SUZUKI
2-Stroke
Service Bulletin
Index

Bulletin No: GT-1
Date: May 1, 1975

Subject GT750 COOLING SYSTEM

1. STARTER CLUTCH HOUSING

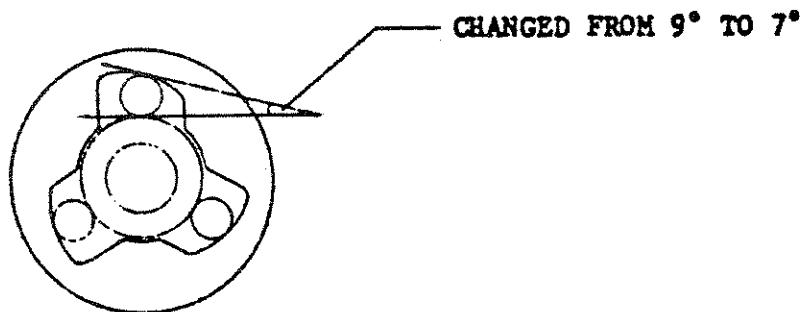
The wedge has been altered as shown in the illustration.

3. STARTER CLUTCH GEAR

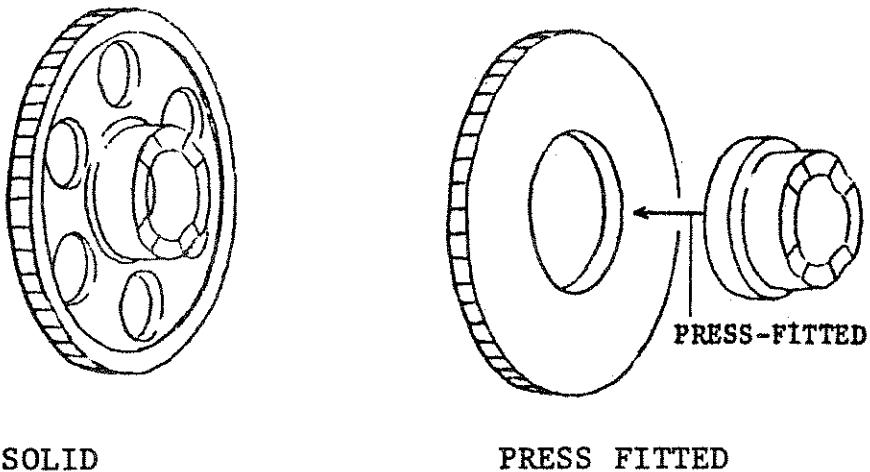
The hub on the starter clutch gear on which the starter clutch rollers run has been changed from a solid type to a press-fitted type as shown below.

4. CRANKSHAFT LH OIL SEAL

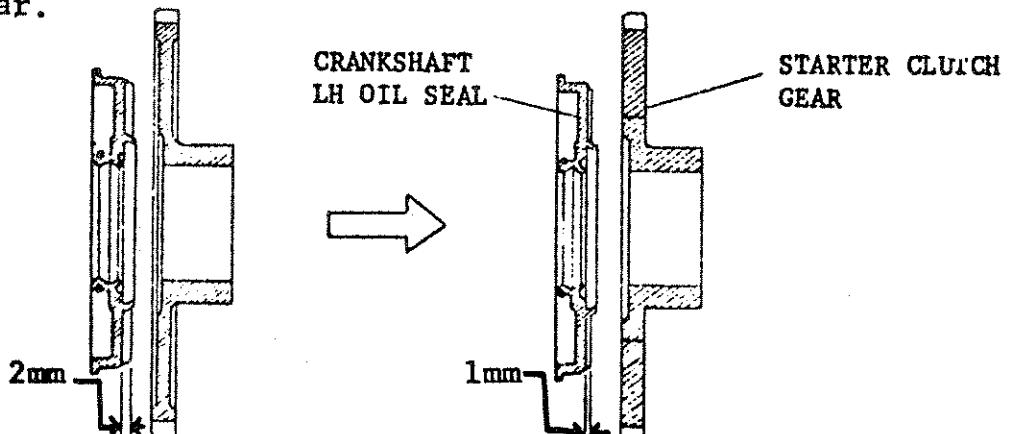
In connection with the modification of the starter clutch gear the thickness of the gear is evened so as to have enough contact surface around the hub being press-fitted.

In addition, the height of the ribs on the crankshaft oil seal have been lowered by 1 mm in order to clear the starter clutch gear.

Note:

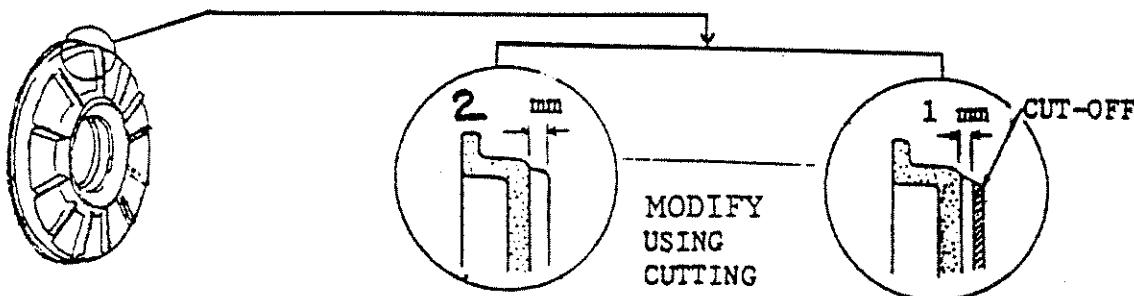
On future parts orders only the new type starter clutch parts will be supplied. However, the old type LH crankshaft oil seal will still be supplied until such time as the existing stock is exhausted. Therefore, when the old oil seal is retained in the unit and the starter clutch is modified or replaced, it is necessary to check the rib height of the oil seal and modify the same as shown.

F.) **Cylinder gasket:**

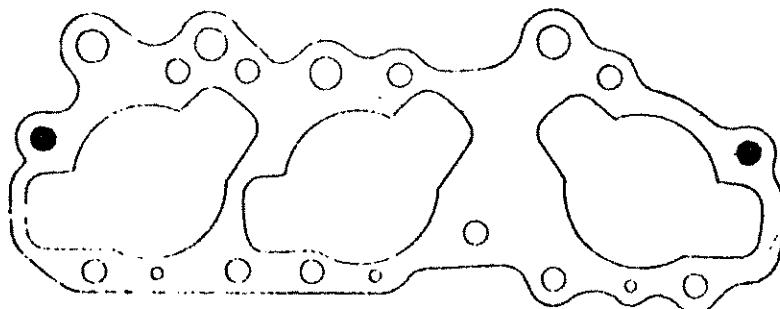
Two holes in the gasket have been enlarged from 11mm to 12.5mm in diameter to match the new type stud bolts.

MODIFICATION:

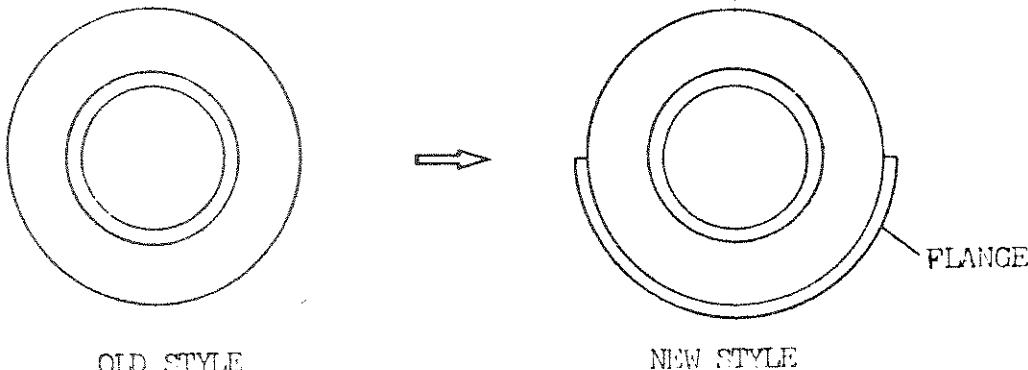
To provide a more positive method of positioning the right inboard oil seal, a metal flange has been added to the seal.

The new style seal's flange eliminates the old style seal's positioning "C"-ring (Part No. 09390-78003). The flange of the oil seal should be placed in the "C"-ring's crankcase groove when positioning the crankshaft assembly in the lower crankcase half.

I. Cylinder:

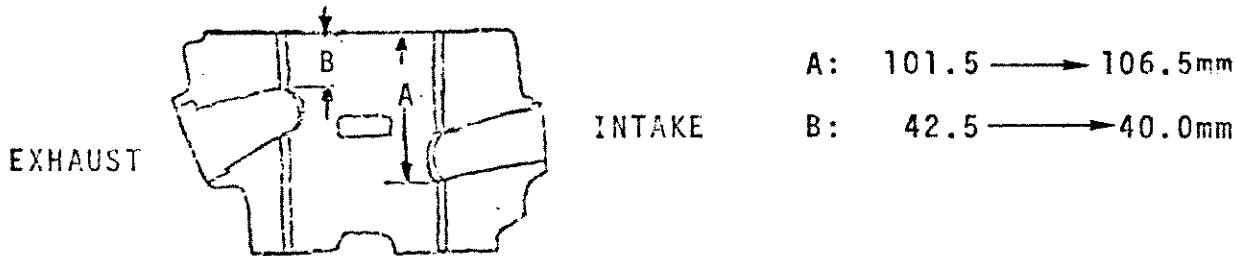
The cylinders intake and exhaust port timing have been changed as indicated.

II. Cylinder Head:

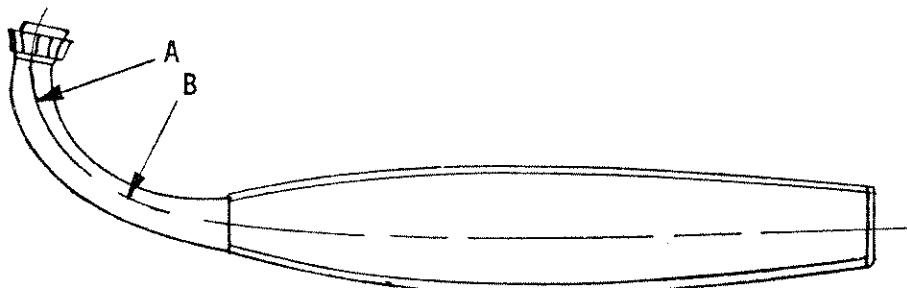
- a. To decrease the combustion chamber volume from 30.6cc to 29.7cc, 0.2mm has been removed from the cylinder head surface.
- b. At the same time, the cylinder head gaskets thickness has been decreased from 1.5mm to 0.8mm.

The above changes (a & b) have increased the compression ratio from 6.7 to 6.9:1.

IV. Clutch Cork Plates:

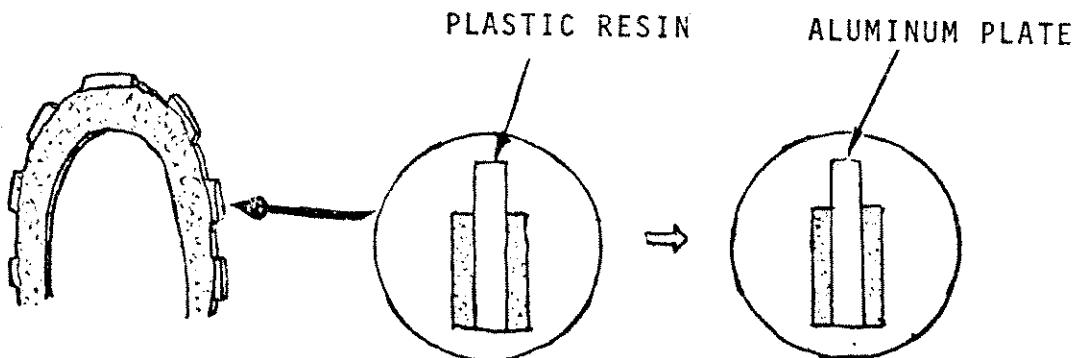
The clutch cork plate's base material has been changed from plastic resin to aluminum.

V. Primary Driven Gear Bushing:

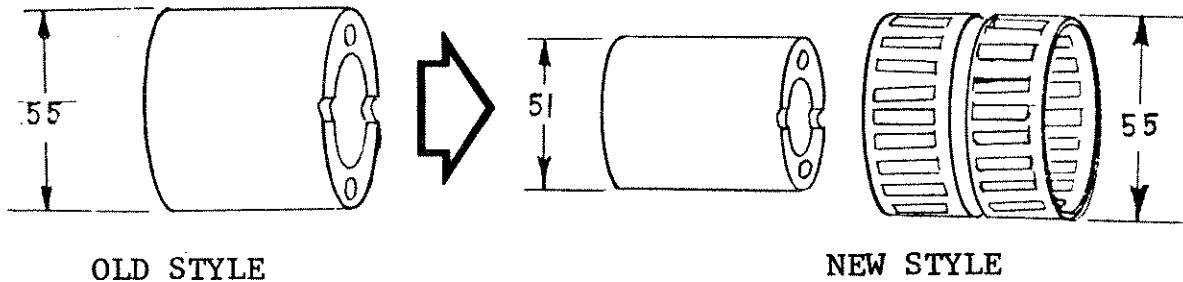
The primary driven gear bushing outer diameter has been reduced from 55mm (2.16in.) to 51mm (2.00 in.) to accompany a new needle bearing now being used.

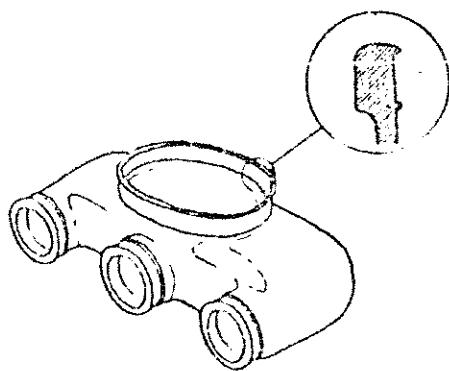
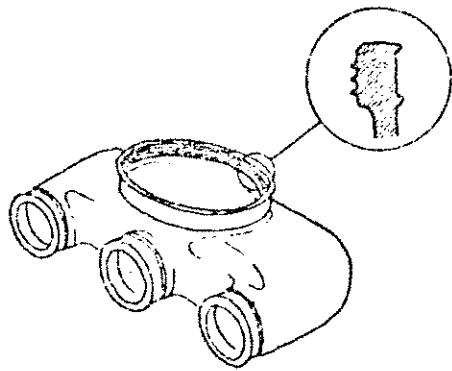
During assembly of the GT380, GT550, and GT750, the carburetor air inlet hose is sealed with "Suzuki Bond No. 4."

Needle Bearing:

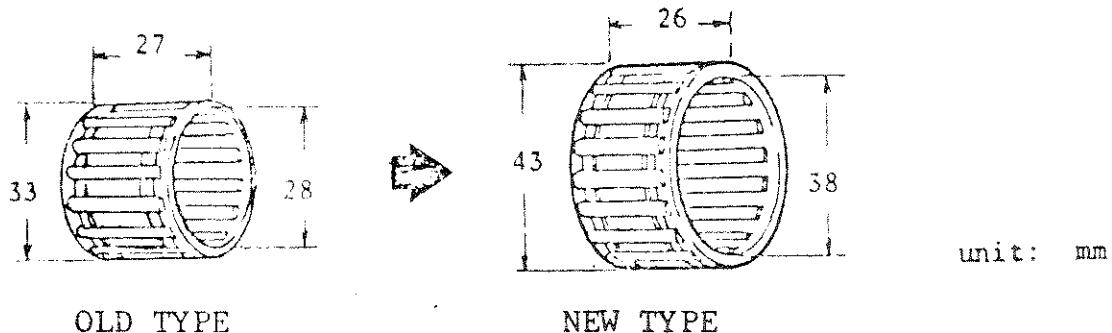
The dimensions of the needle bearing have been changed as shown.

Primary Driven Gear Spacer:

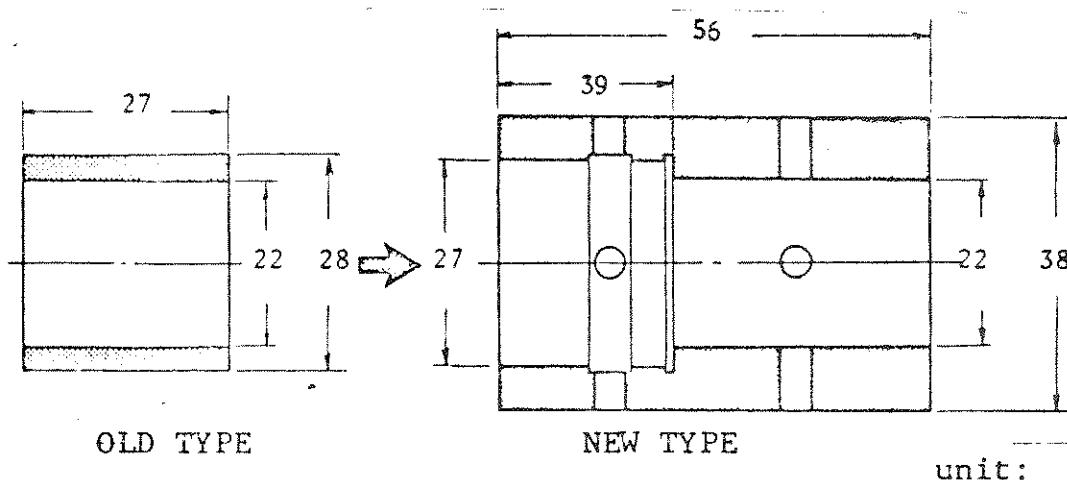
The dimensions and shape of the primary driven gear spacer have been changed as shown.

Primary Driven Gear Assembly:

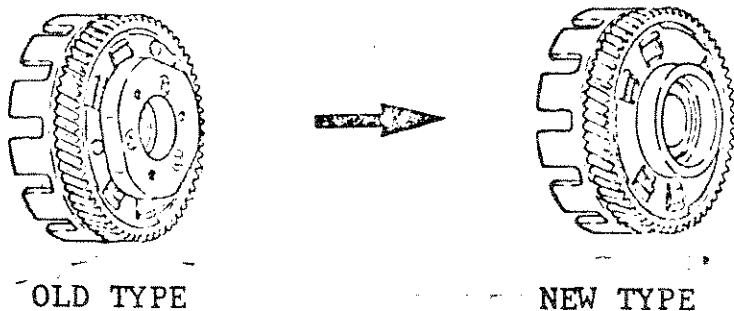
The primary driven gear assembly has been changed to incorporate the new one-way starter clutch.

Starter Clutch Gear:

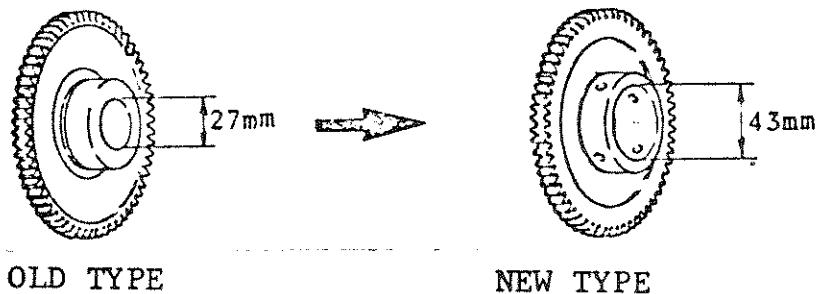
The shape and inside diameter of the starter clutch gear has been changed as shown.

IV. Rear Brake Panel

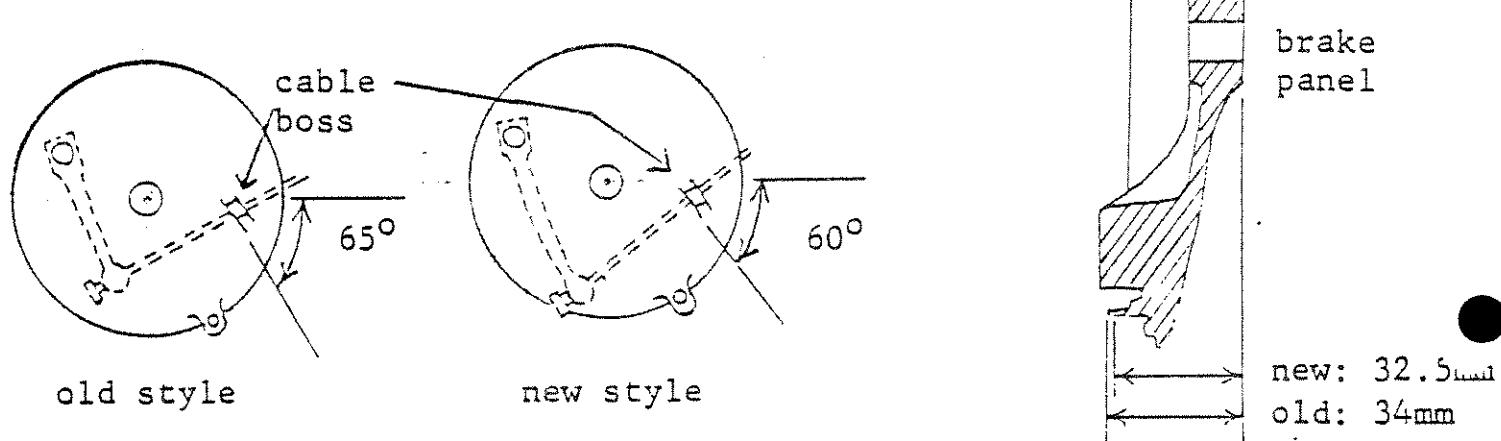
In compliance with changes I, II, III, the rear brake panel (brake backing plate) has undergone two changes: the first change is the angle of the cable boss in conjunction with the increased length of the cam lever. Secondly, at the same time the width of the panel has been decreased 1.5mm, as shown.

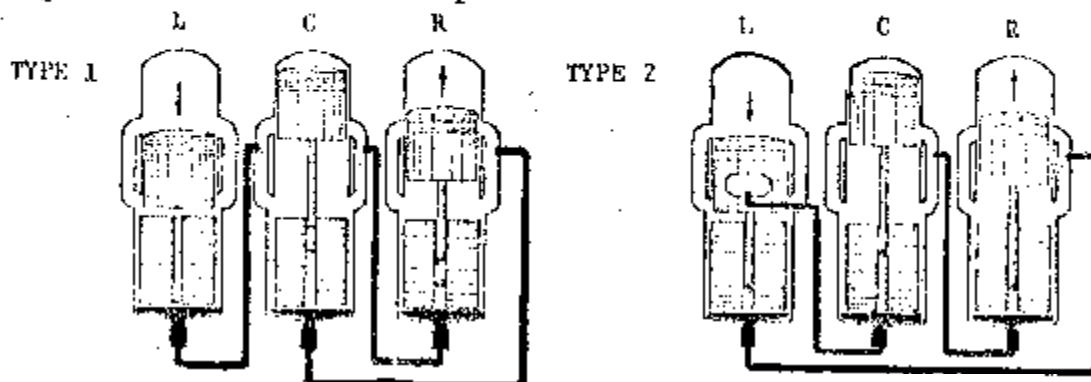
As explained in the Service Manual of GT750, there are two types of the SRIS piping shown below and the type 2 in the illustration has been applied to the production since just before the yearly change of 1973 and the initial number of the modified engine is GT750-31344

The reason for this modification is to rectify the symptom that the engine of the type 1 tends to emit a little thick fumes from the right hand muffler as compared with the others

In order to provide for this request, a modification kit has been prepared to convert the early engine to the new type in principle and it now available as a spare part.
